10 Newlands street
Chery Chase

MAWP 35/13-08P
+ 2009 revision

Permit Revision #2

The HPC approved a HAWP in August 2008 for a rear addition to the house at 10 Newlands Street (Contributing Resource). The applicants are now proposing minor changes at the rear of the house—changes to the pattern of the wood French doors on the rear addition and a wood pergola instead of a porch in the center connecting the two rear porches. They also propose to replace the below-grade basement windows with wood windows. All of these changes are allowable and staff is asking the HPC to approve staff level approval of these changes.

Proposed
revision

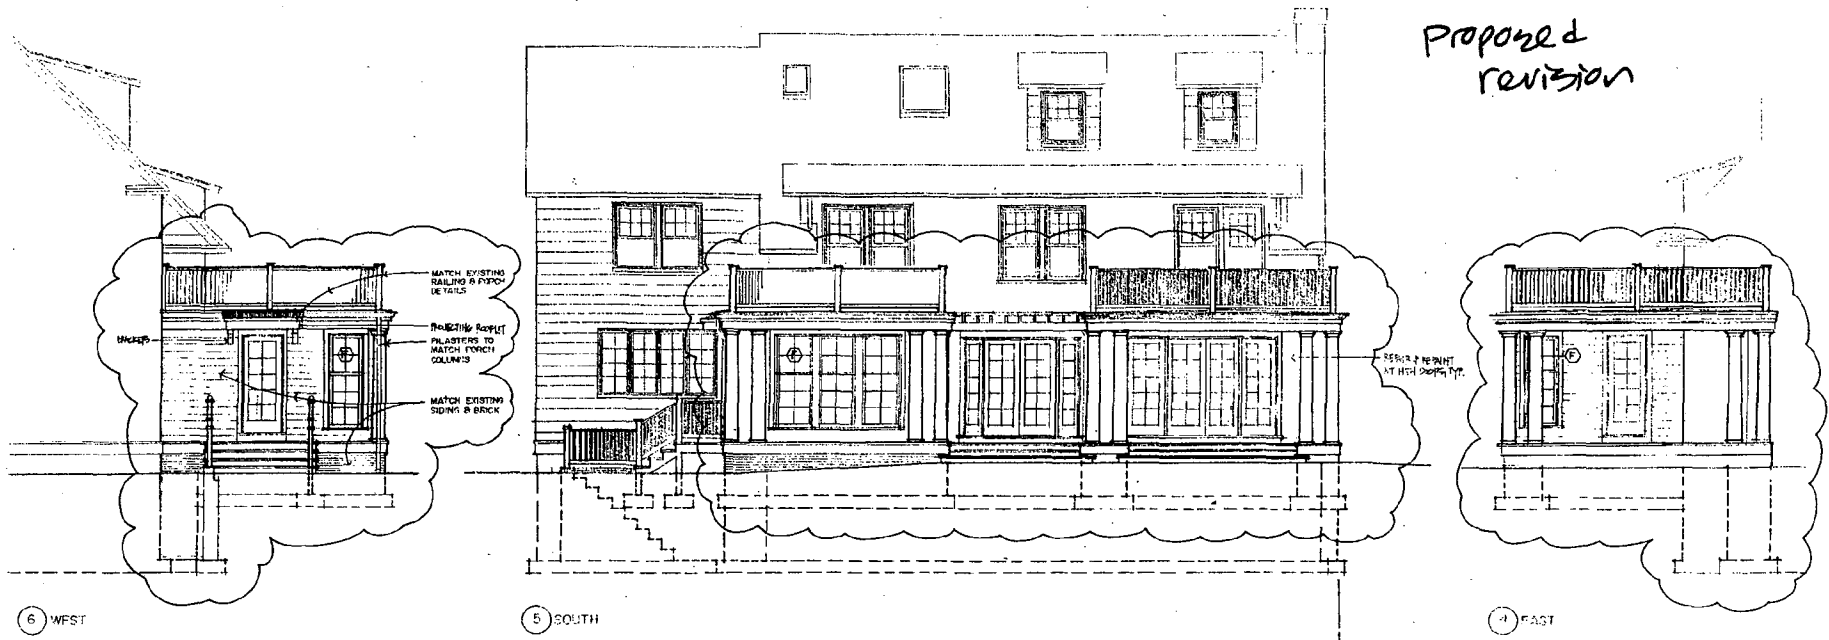
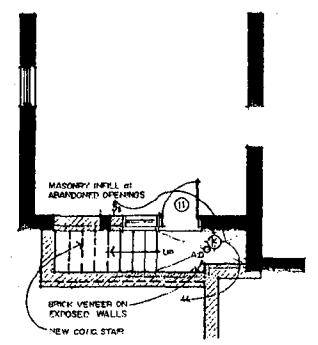
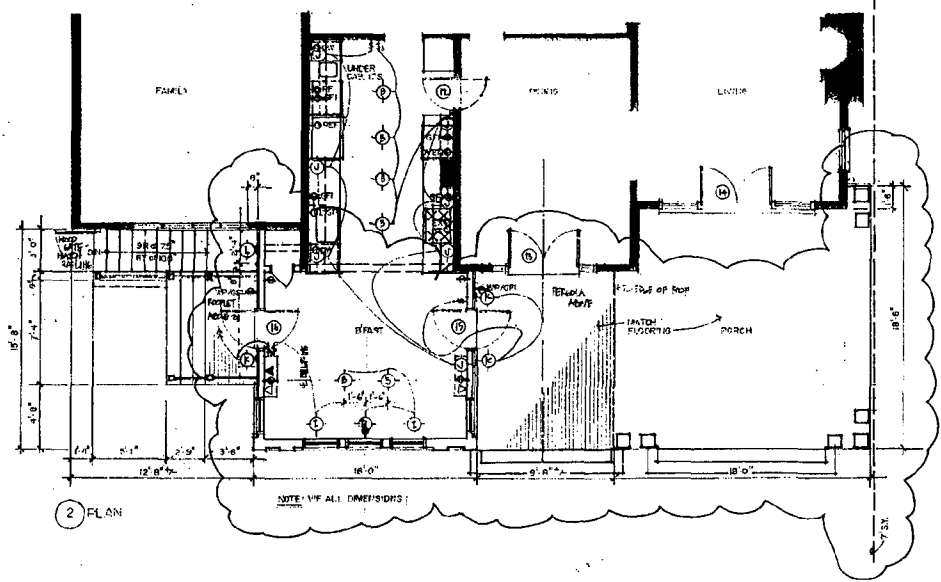
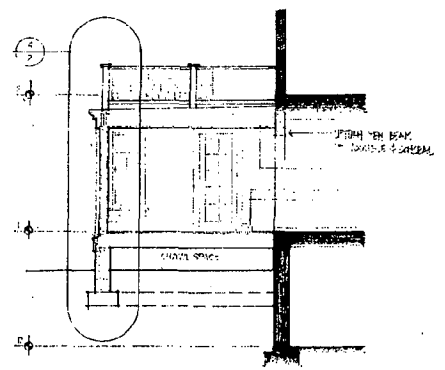
- Remove the existing one-story rear porch and construct a new 18' x 18'6" porch to conform with the side yard setback; materials and details to match existing porch
- Add wood sidelights to the rear doors
- Reduce number of windows in addition from four to three and increase pilasters from two to four

1. Remove the existing one-story rear porch. The porch is structurally deficient and does not comply with zoning setbacks.
2. Replace the porch with a new porch matching existing details and materials. The new porch is more narrow to conform to the side yard setback, and deeper to align with the breakfast room.
3. Add sidelights to the rear dining room doors.
4. Change the four rear windows in the breakfast room to three.
5. Adjust the pilaster detailing on the breakfast room to coordinate with the window revision in 4. above.
